Watts Bar Nuclear Plant, Unit 2
NRC Docket No. 50-391

Subject: WATTS BAR NUCLEAR PLANT (WBN) UNIT 2 – RESOLUTION OF CONCERNS WITH FIRE PROTECTION REPORT (FPR) OPERATOR MANUAL ACTION (OMA) 732 AND RESPONSE TO REQUESTS FOR ADDITIONAL INFORMATION (TAC NO. ME3091)

Enclosure 1
Response to NRC's June 7 2012, Request for Additional Information (RAI)

WBN-VTD-AS06-0160

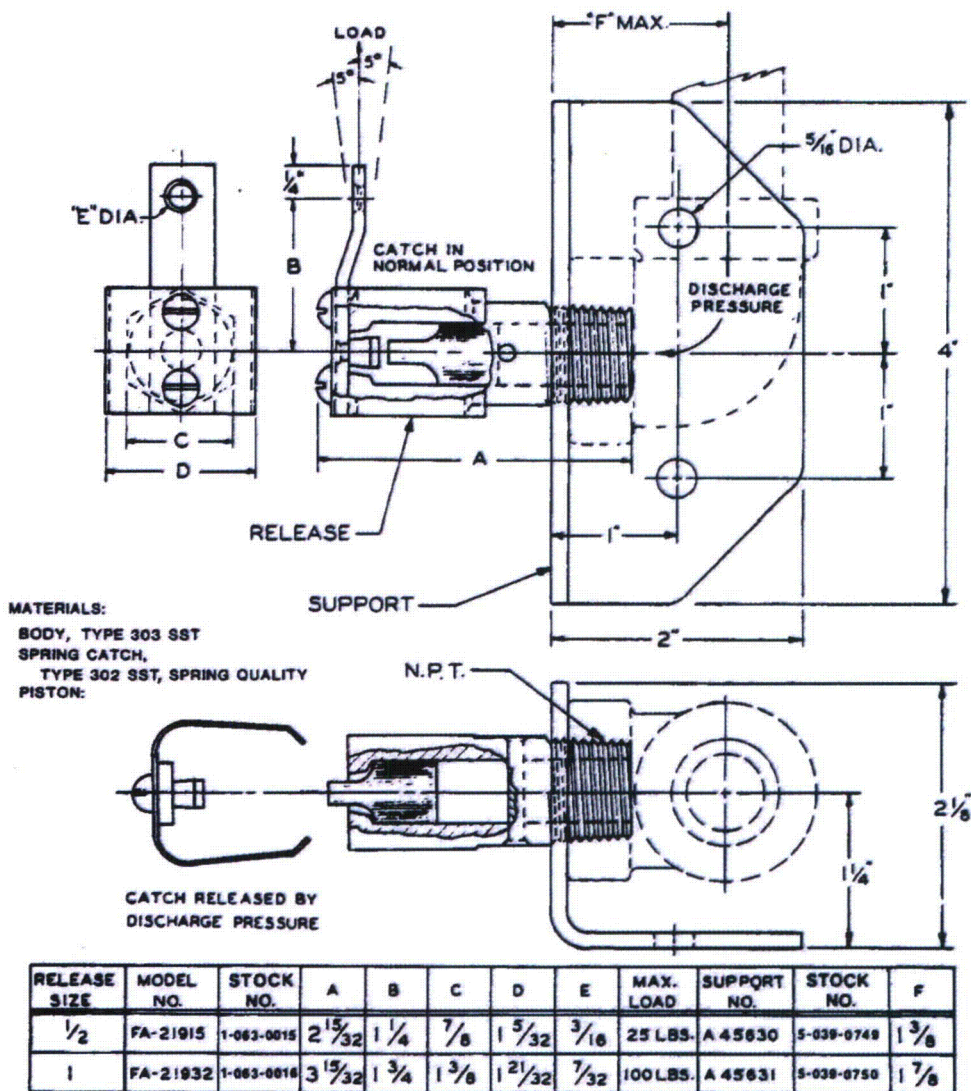
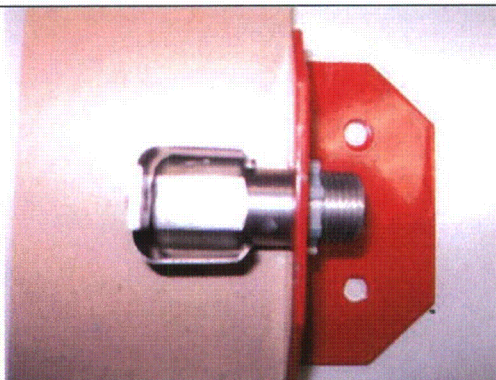
The vendor supplied CO₂ gas operated blow-off clips are a combination device. The first part is the fitting attached to the CO₂ piping. Inside this fitting is a piston with an extension on the outboard side that slides into an outlet of the fitting when the piping is pressurized on the inboard side of the piston. The second part is the clip that has an extension that fits into the fitting's outboard outlet. When the piping is not pressurized, the clip extension fits into the outlet and a cable is attached at an approximate 90 degree angle to hold the device in question (e.g., door or damper release) in place. When the CO₂ piping is pressurized, the fitting's piston extension drives into the outlet forcing the clip off the fitting and thus releasing the held device. For additional information, please refer to the attached vendor sketch and the picture provided on the last page of this enclosure.
